CITY OF NAPOLEON
ENGINEERING DEPARTMENT
APPLICATION for SIGN PERMIT

TO: Members of the Board of Zoning Appeals
FROM: Roger O. Freytag, Zoning Administrator *ROF*
SUBJECT: An application for Variance to erect a dealer
sign on a 24' pole
DATE: 4 Aug 1989
MEETING: 8 Aug 1989 at 4:30 PM
MEETING NO.: BZA 89/14

PROPOSED FOR BILL MODERN SIGN
lighted sign, existing lighted North

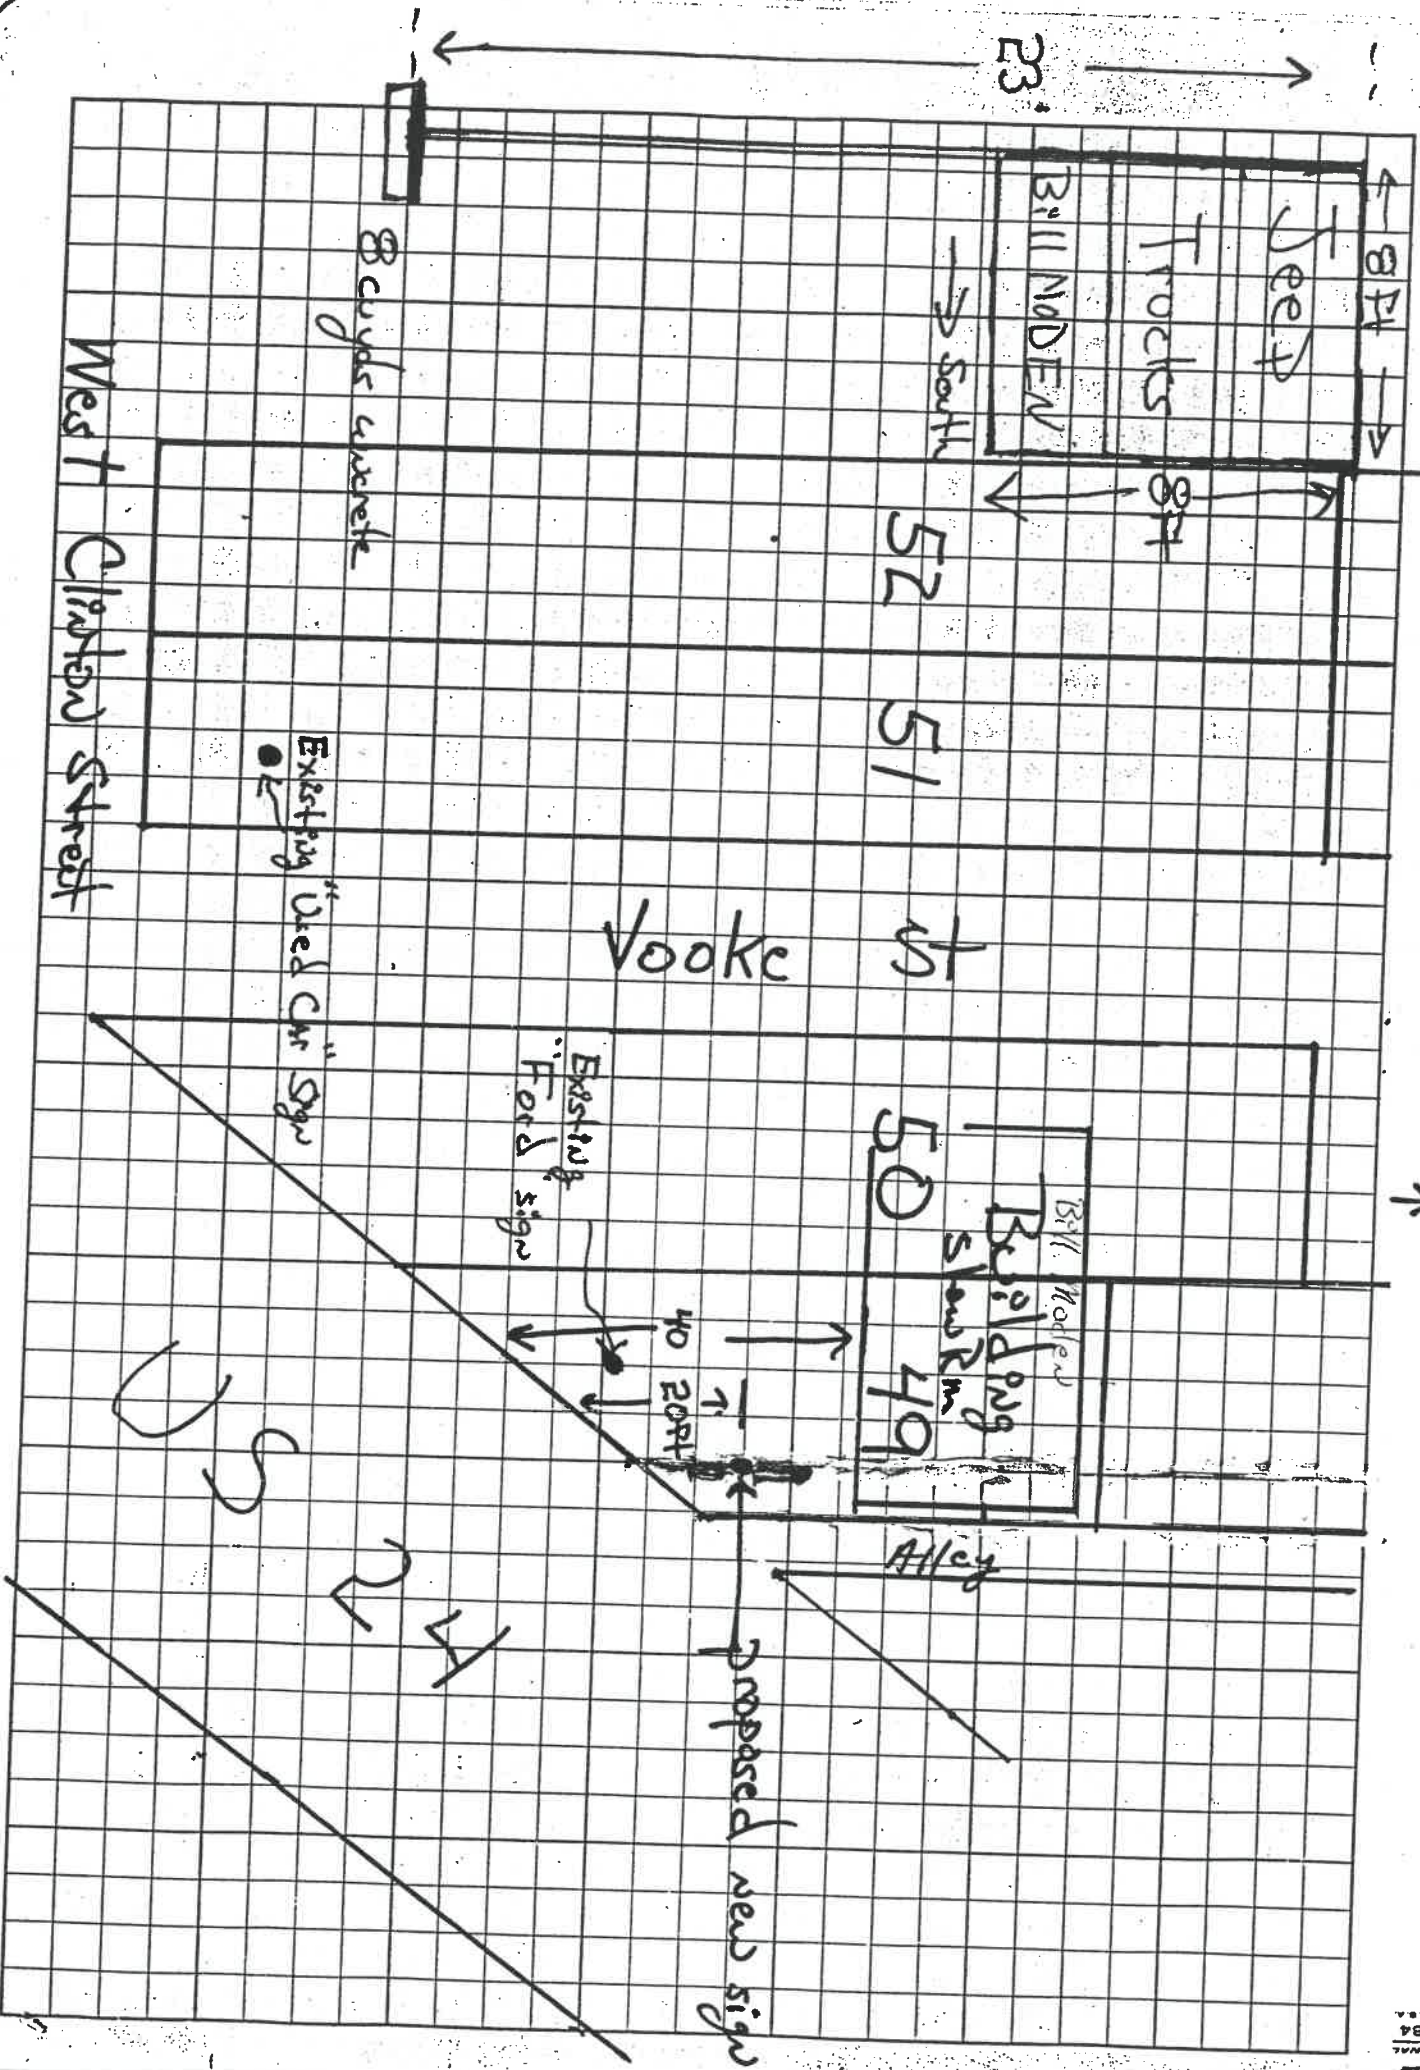
It is recommended that the Board of Zoning Appeals not approve the Variance as requested, but recommend a Variance be granted if the sign is located off the Right of Way area.

The Variance requested is for a sign pole to be located 20.5 feet off the southeast corner of the showroom building. The State Route 424 Right of Way is located at 24 feet off this corner. The sign will extend 8 feet off the pole into the Right of Way area. The City would be in favor of granting the Variance if this sign would not encroach on the State Route 424 Right of Way.

After reviewing this request, the City staff does recommend in favor of granting this request with the above changes.
